SERVICE INSTRUCTION

REPLACEMENT OF THE GASKET RINGS ON THE ADAPTOR OF THE OIL RADIATOR FOR ROTAX® ENGINE TYPE 912 AND 914 (SERIES)

SI-912-011

SI-914-012

Detail gasket ring new version

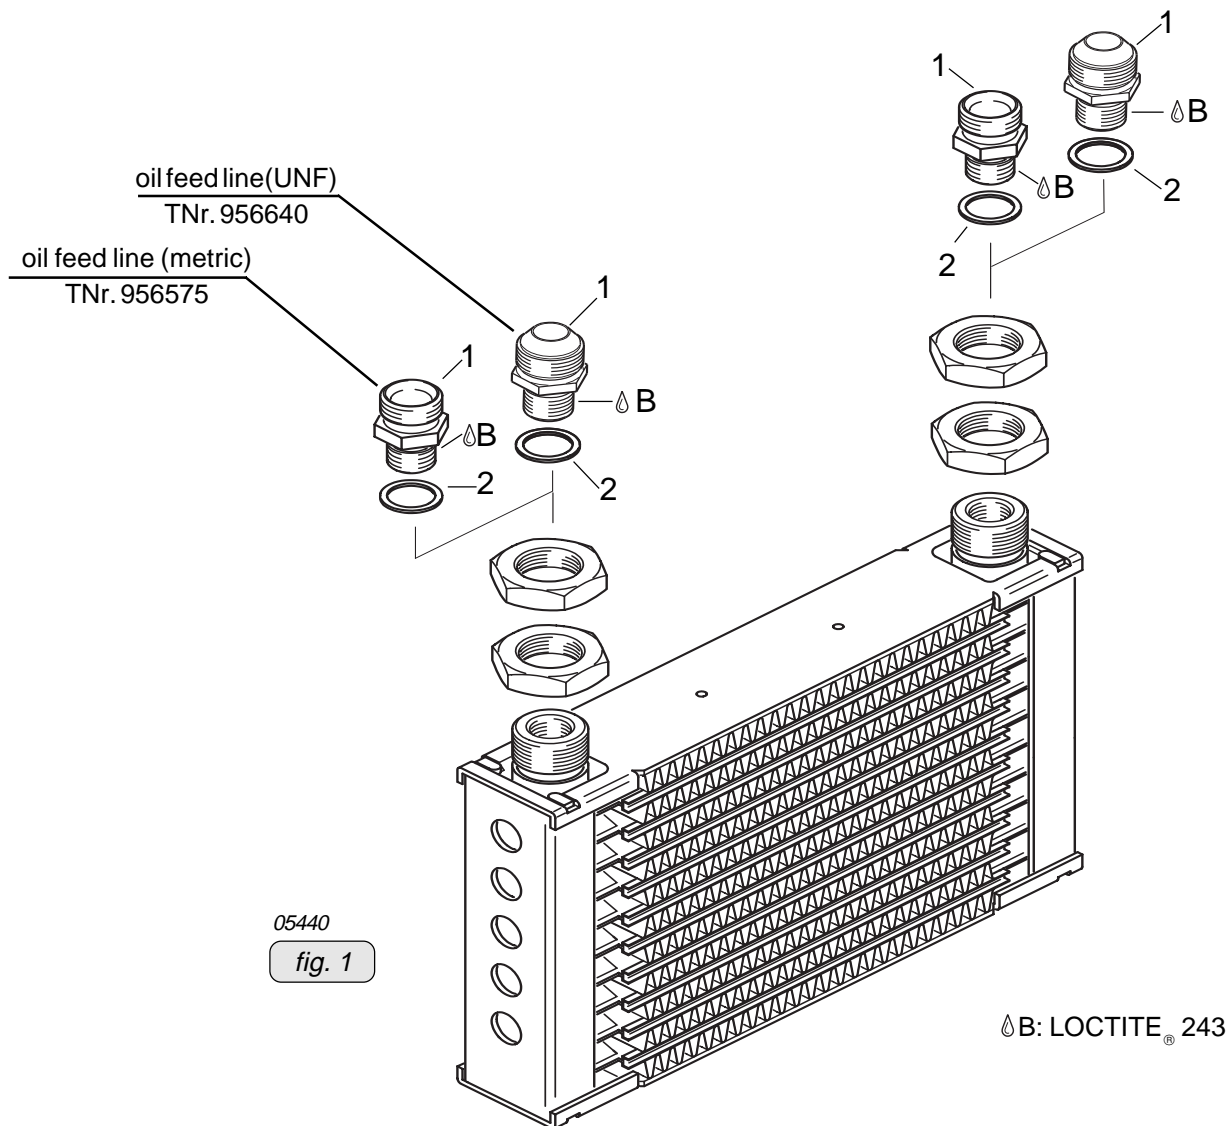
To assure adequate seal and prevent oil leaks, a thicker gasket ring (part no. 230387) has been introduced. This new gasket ring better compensates for dimension abnormalities on the radiator adaptor.

Fig.no.	New p/n	Qty/engine	Description	Old p/n	Application
(1)	230387	2	gasket ring A14,2x18x2	230385	oil radiator

- Fit adaptor (1) part no. 956575 (metric) or part no. 956640 (UNF) with new gasket ring (2) secured with **LOCTITE[®] 243**. Tightening torque **35 Nm** (310 in.lb).
